SUMMARY EXPERT OPINION

AMENITY COMPLIANCE
OVERSHADOWING, SOLAR ACCESS AND CROSS VENTILATION

s96 Application MIXED USE DEVELOPMENT 11 Mashman Avenue Kingsgrove

13 November 2012

Figure 1: Proposed additional storey to Building C

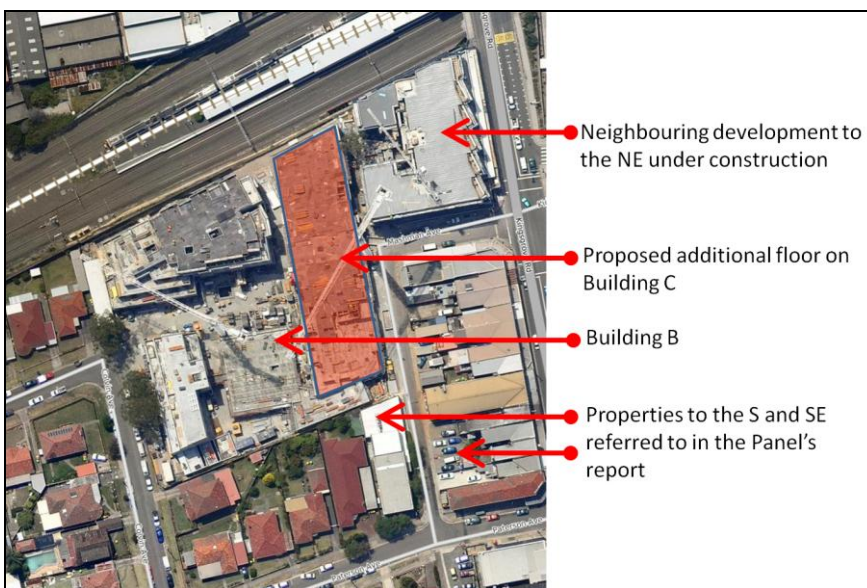
The additional height will have adverse impact in relation to overshadowing and visual impact on the public open space, Block B and properties to the south and south east.
Apart from mid winter overshadowing in the plaza, this proposal will increase overshadowing at other times of the year.

4.2 The current s.96 application is for an additional storey to be added at Level 6 to Building C, being the slab block on the eastern boundary of the subject site. The comments of the Panel may be interpreted by reference to Figure 1, which shows the relationship of the proposed amended building to its immediate context.

Figure 5: Relationship between Building C and adjacent development to the east

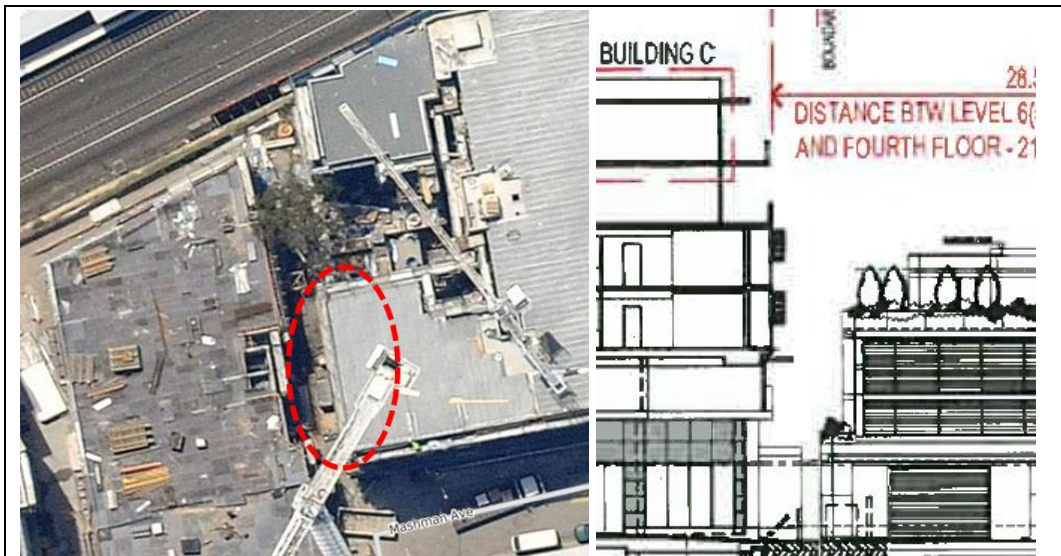
The approved scheme on the adjoining property on the east – currently under construction – will be adversely impacted by this additional height.

The winter impact of an additional storey on Building C is effectively confined to the portion of the courtyard and western façades, at most over the height of one floor, at the location circled in Figure 5. Such additional impact is also likely to be for a very short duration, as the already approved relationship between the buildings defines the afternoon overshadowing (See the section in Figure 5). I have no information relating to the internal planning of the building under construction. But I think it can be safely inferred that this is likely to be a single apartment.

There is some summer impact on the west façade of the courtyard, but this appears to be largely the wall of a lift core.

There is, technically, a minor impact on *daylight* (as distinct from solar access), but it is likely to be negligible compared to the effect of voluntary use of window treatments to control privacy by residents of both buildings.

In brief, overshadowing impacts on neighbouring properties that can be attributed to the proposed additional storey height on Building C are very small, if not negligible.
